## PLANNING AND COMMUNITY DEVELOPMENT STAFF REPORT

<b>PLANNING COMMISSION AGENDA ITEM # 7: DPF-09-06</b>	
<b>Project Name:</b>	Walton Pond Townhomes II – Walton Pond Sub Filing 2, Lot 2
<b>Prepared By:</b>	Seth E. Lorson, City Planner (Ext. 280)
<b>Through:</b>	Tom Leeson, AICP, Director of Planning and Community Development (Ext. 244)
<b>Planning Commission (PC):</b>	February 11, 2010
<b>City Council (CC):</b>	March 2, 2010
<b>Zoning:</b>	Community Commercial (CC)
<b>Applicant:</b>	Curt Weiss c/o Ed Becker, Mountain Architecture P.O. Box 770420 Steamboat Springs, CO 80477
<b>Request:</b>	Development Plan/Final Development Plan (DPF) for a multi-family development to create 14 new townhomes (9 net) with 2 variances: sidewalk & transparency.

Attachment 1 – Site Plans

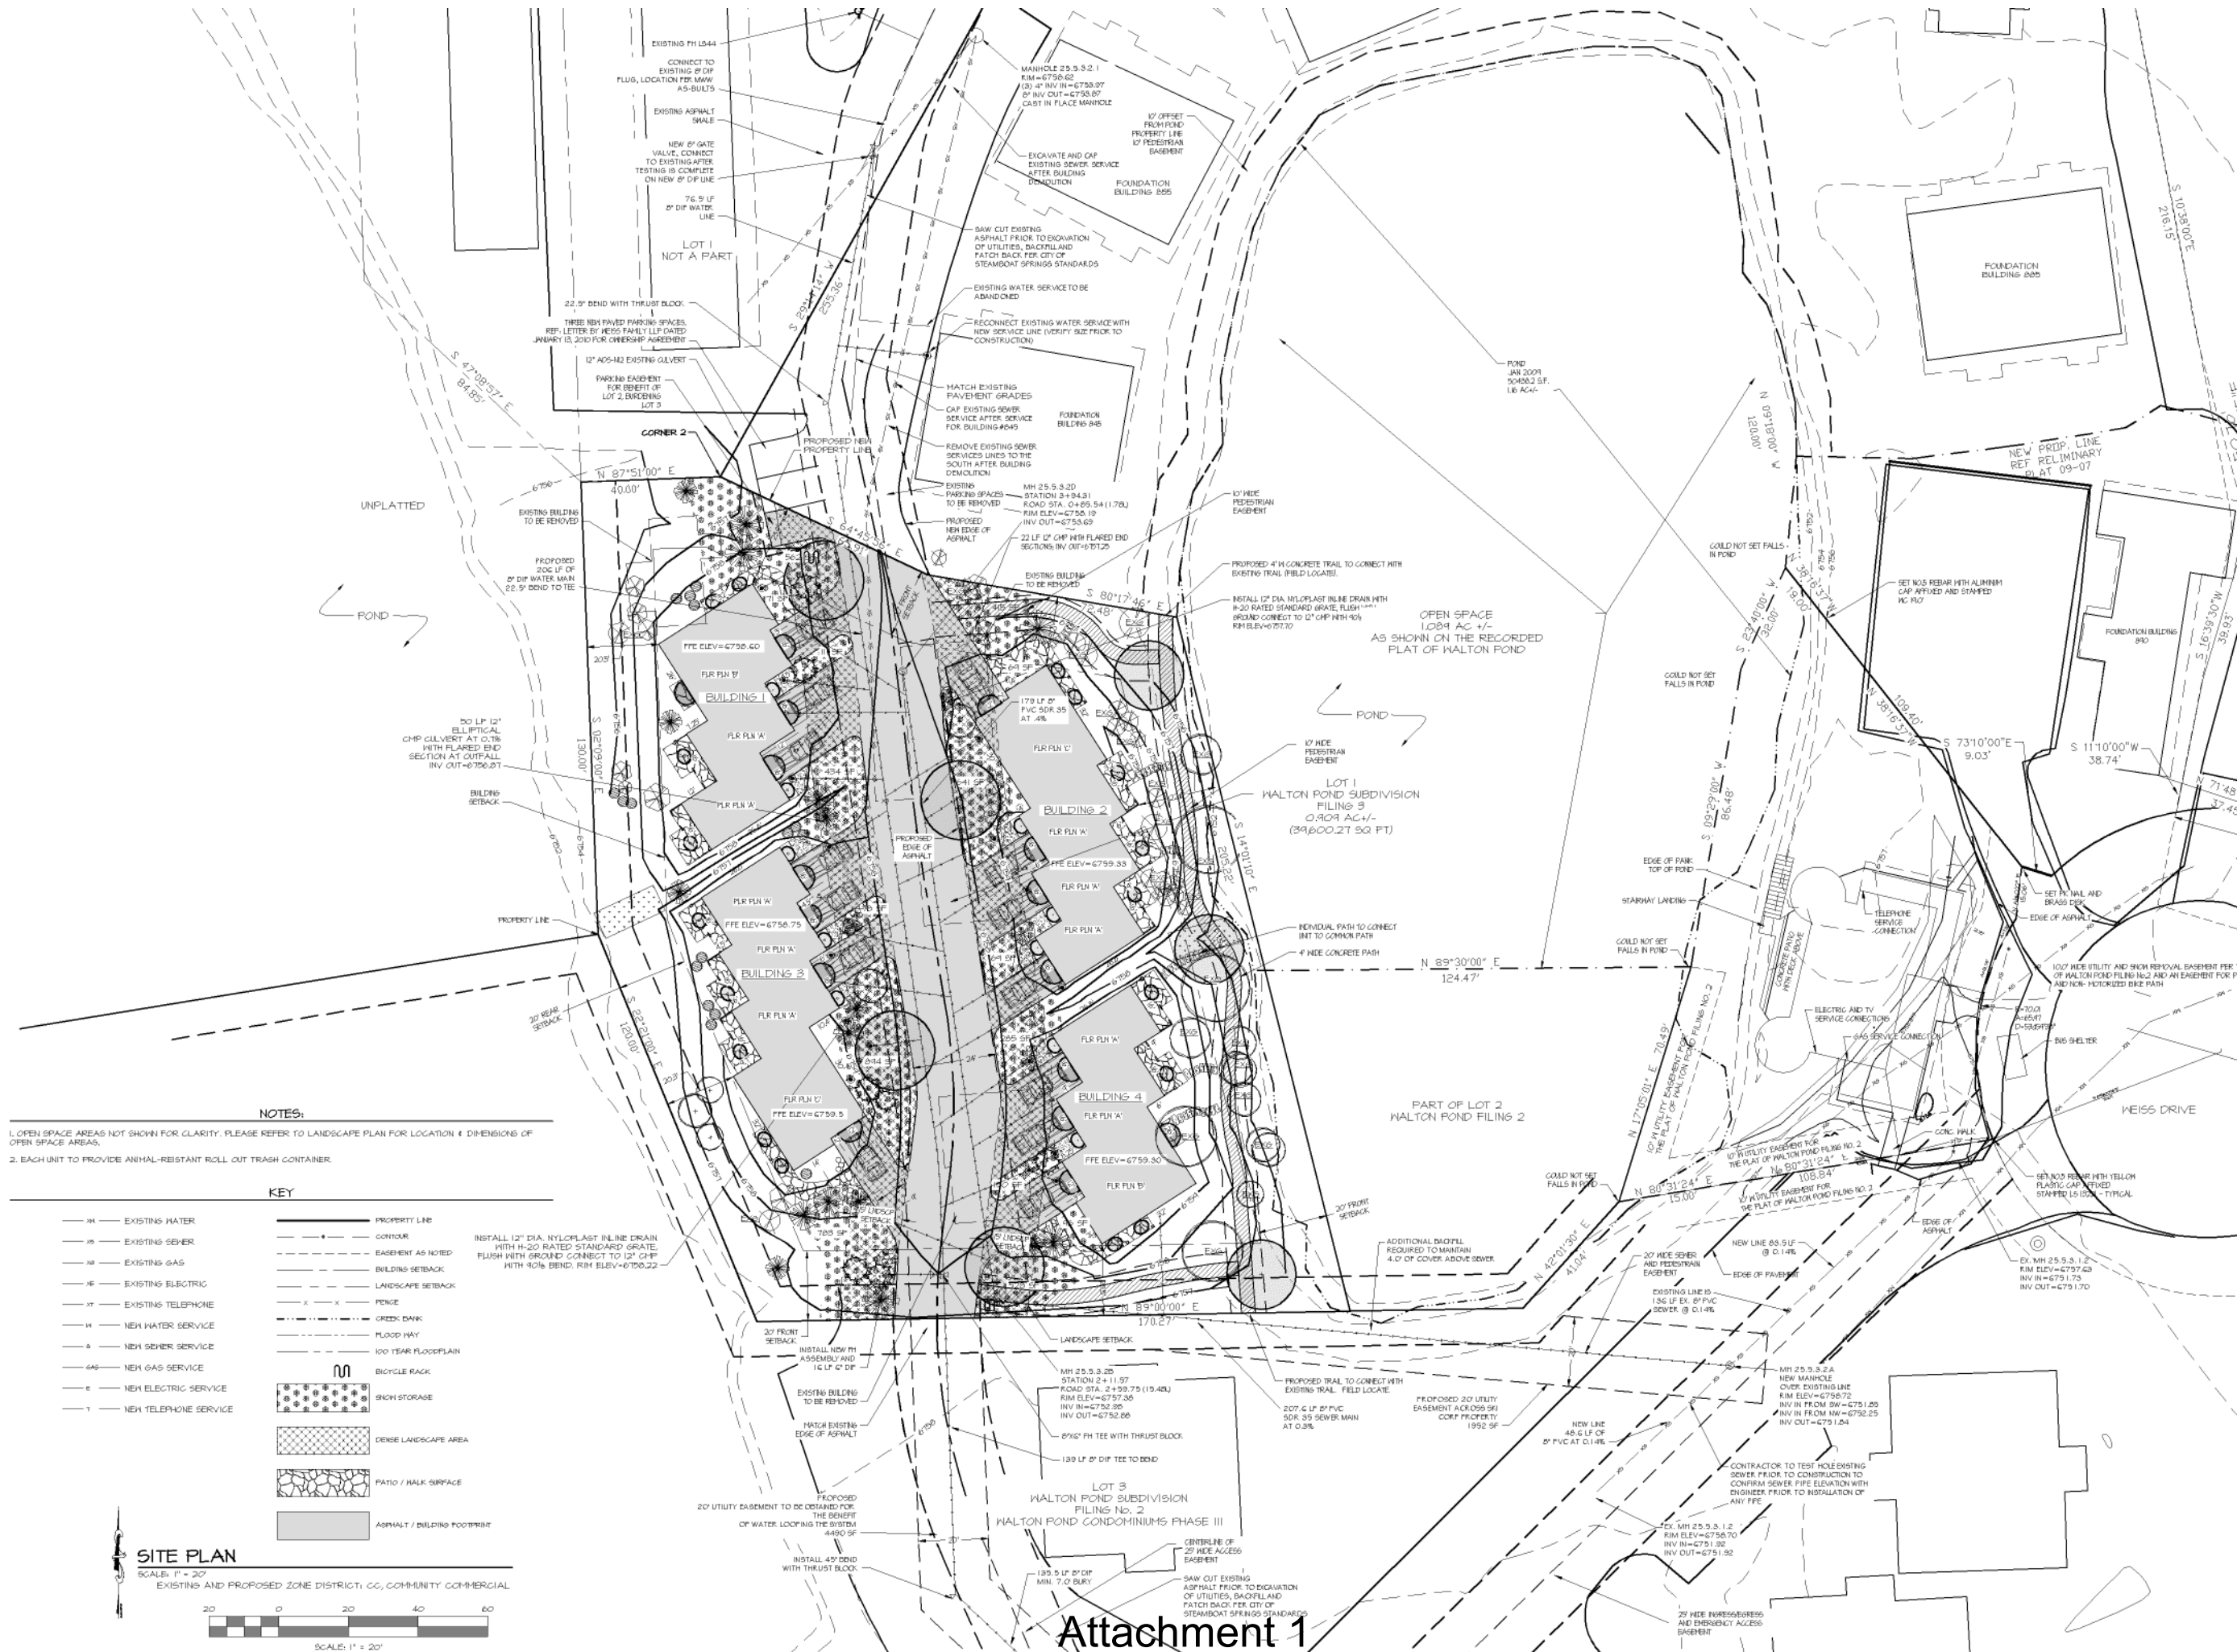
The site plan proposed to have one access road splitting the buildings, two on each side facing the road. A sidewalk is proposed along the back of the east side buildings with accesses to the road. No sidewalk is proposed along the road. With the site layout as proposed, staff has considered it to have a double-front setback.

Staff finds that the proposed variance to the sidewalk criteria in both the CDC and the Urban Design Standards does not meet the variance criteria. Specifically, the applicant has not provided any plan to mitigate the impact of not creating a sidewalk. Through the review process, staff recommended a sidewalk along the south side of Walton Pond from the proposed development to the bus shelter on Weiss Circle. The recommended sidewalk would go across the adjacent property (SSRC) through a green belt and be a fraction of the distance to travel than going around to the North. This would require a pedestrian/sidewalk easement to be granted by SSRC. There are a couple reasons staff thought it is a reasonable request for the applicant to ask for an easement. First, an easement on the same property needed to be obtained for water/sewer looping and discussion with a representative, SSRC was open to the proposal. Second, the alternative sidewalk that staff thinks would meet the variance criteria is far shorter (lower cost to the applicant) and would suffice to meet the needed connectivity instead what is required by the standards in the CDC.

(1) a. 3. Except as otherwise stated within this section, all sidewalks shall be constructed to standards currently on file with the director of public works. Sidewalks are to be constructed of concrete unless otherwise determined by the director of public works.	<b>4' wide sidewalk along back side of lot. Not proposed to standards.</b>

(1) b. 1. Sidewalks shall be provided to connect each individual building to any adjacent perimeter sidewalk.	<b>Stepping stones proposed.</b>
	(1) b. 2. Each development shall provide pedestrian connections to adjacent properties, where possible, forming an interconnected pedestrian circulation system.	<b>Connection to north but not south.</b>

Staff Analysis: **NOT CONSISTENT**; As the proposed development has inadequate sidewalks it does not meet the *SSACP Policy T-2.1: New development shall include an interconnected pedestrian and bicycle system.*

**Staff Analysis: NOT CONSISTENT;** By not providing sidewalks along the road pedestrians passing through the site from adjacent properties are forced to walk in the street. The applicant has not “accurately assessed the impacts of the proposed variance” and has not agreed to mitigate those impacts. See *Principal Discussion Items* section for further discussion.

TITLE  
**SECTION 3  
BUILDING 1+3  
ELEVATIONS**

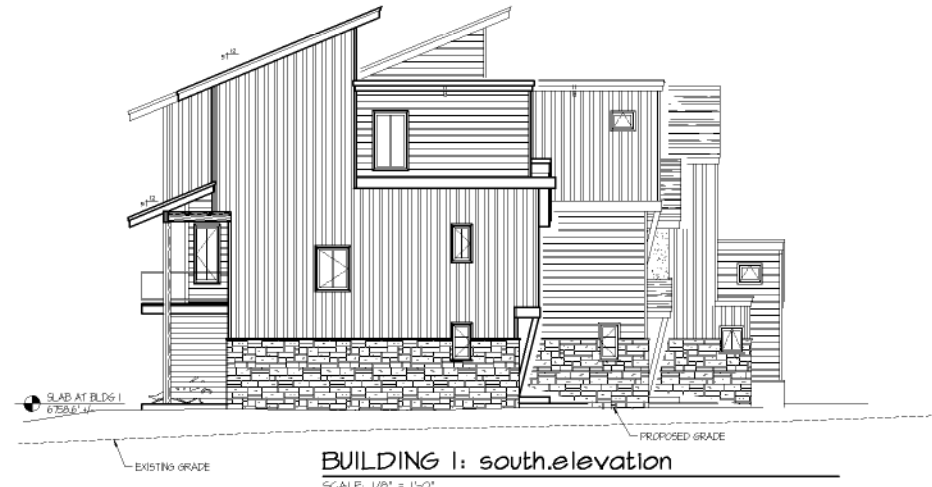
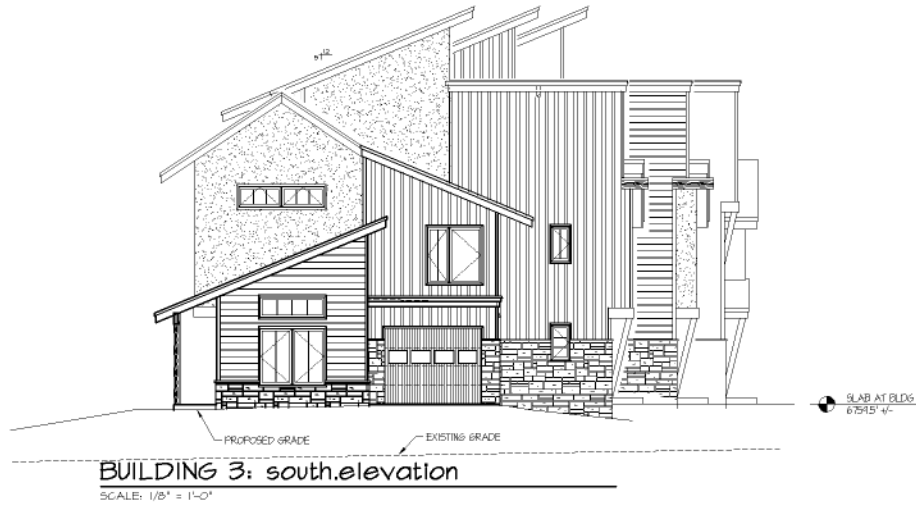
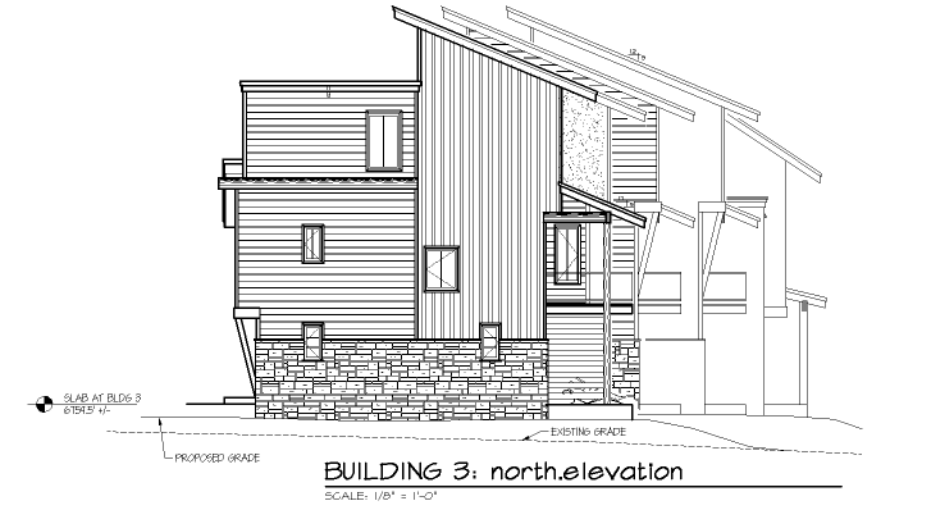
<i>Transparency (Sec. III, pg. 39)</i>  <b>VARIANCE REQUESTED</b>	All multi-family building elevations shall devote a minimum of 25 percent of the wall area of each floor to windows or transparent entrances.	<b>15 %</b>

Staff Analysis: **Consistent;** Injury to adjacent property is not anticipated with the variation from 50 % transparency to 15% transparency on the 3<sup>rd</sup> floor.

Staff Analysis: Consistent; The applicant has provided 30% of the standard and has maintained compliance with the International Building Code.
